From: Scott & Stacy Reed, Property Owners
12424 NW Springville Road, Portland, OR 97229

Re: Applicant’s Presentation
Public Hearing on Appeal of Notice of Decision (T2-2021-14981)

The purpose of this Type II appeal is to highlight an error in Multnomah County Department of Community Services Land Use Planning Division’s (“LUP”) review of the application for the proposed farm dwelling at 12424 NW Springville Road in Portland and to address code sections identified in the Notice of Decision (dated June 14, 2022) as “Criteria not met” or “Standard not met”. Below is an outline of the Multnomah County Code sections that will be covered in this presentation. Each code section or LUP staff comments will be included in this presentation and all comments within the code section or staff comments made by the Reeds will be in **bold**.

6.5

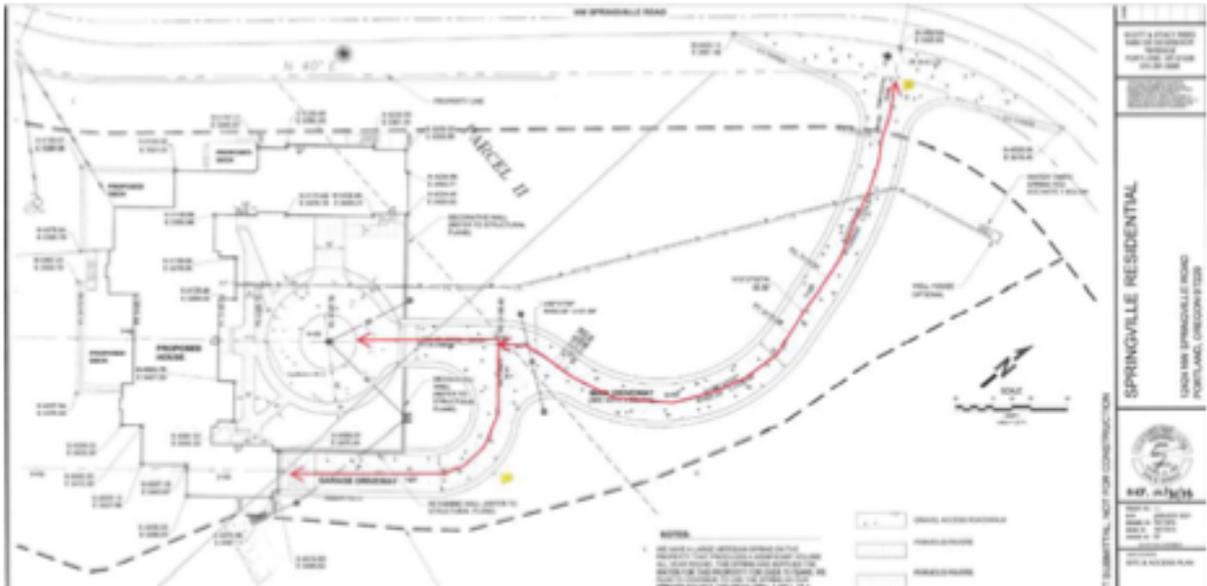
According to the applicant, the road/driveway (not including the roundabout) is 466.97 ft. The proposed site and access plan (Exhibit A.16) shows the length of the access road/driveway and service corridor is approximately 589 ft. The image below is a copy of Exhibit A.16, which shows the access road/driveway and service corridor identified with red lines (with a portion of the roundabout not included for purposes of the illustration).

In the September 08, 2021 Incomplete Letter (Exhibit C.1), staff informed the applicant that the proposed access road/driveway and service corridor serving the development exceeds 500 feet. Staff noted that the applicant therefore needed to develop a Wildlife Conservation Plan that satisfies the requirements of MCC 39.5860(C). In the February 14, 2022 Applicant Response Letter (Exhibit C.3), the applicant declined to submit the requested Wildlife Conservation Plan. Standard not met.

The Reeds never “declined to submit the requested the requested Wildlife Conservation Plan.” The civil engineer of record measured the driveway utilizing a CAD program at 466.97 linear feet. The exact same proposed driveway and location was reviewed and approved by Multnomah County Land Use

Planning Division on September 11, 2015 (Case File: T2-2014-3377) as being less than 500'. Chris Liu measures the driveway length via a pdf copy as "approximately 589 ft." Therefore, we retained Winterbrook Planning to hire Anita Cate Smyth (SPWS) to complete a Wildlife Conservation Plan for our proposed farm dwelling (see Exhibit K-Wildlife Conservation Plan).

7.1

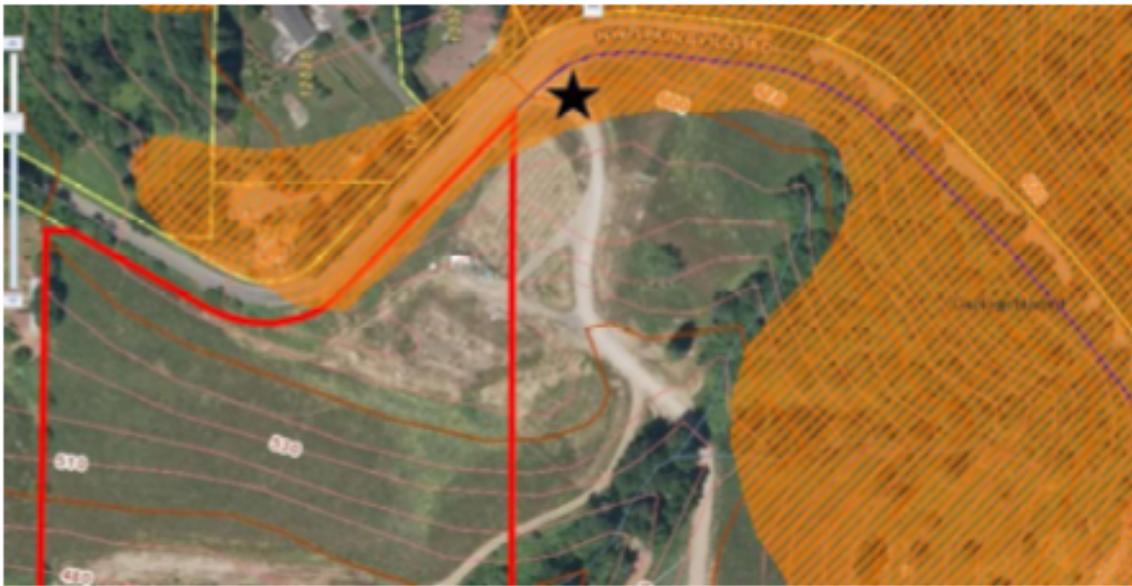
The subject tract contains areas within the mapped Geologic Hazards (GH) overlay [designated with an orange crosshatch], as shown in the image below. These areas within the GH overlay include a portion of the planned access road/driveway, which is marked with a black star. The tract also contains areas with steeper slopes, as shown by the contour information in the image below. The image below is a screenshot of County GIS information.

The "access road/driveway" is not "planned" as it was completed over five years ago under driveway/ROW permit #80244 with the approval of Eileen Cunningham, Transportation Planner for the Multnomah County Transportation Program at the time of permit issuance (see Exhibit L-Original Driveway/ROW Permit). The driveway was built out according to the site plans that are incorporated into the driveway/ROW permit. Eileen Cunningham no longer works for Multnomah County.
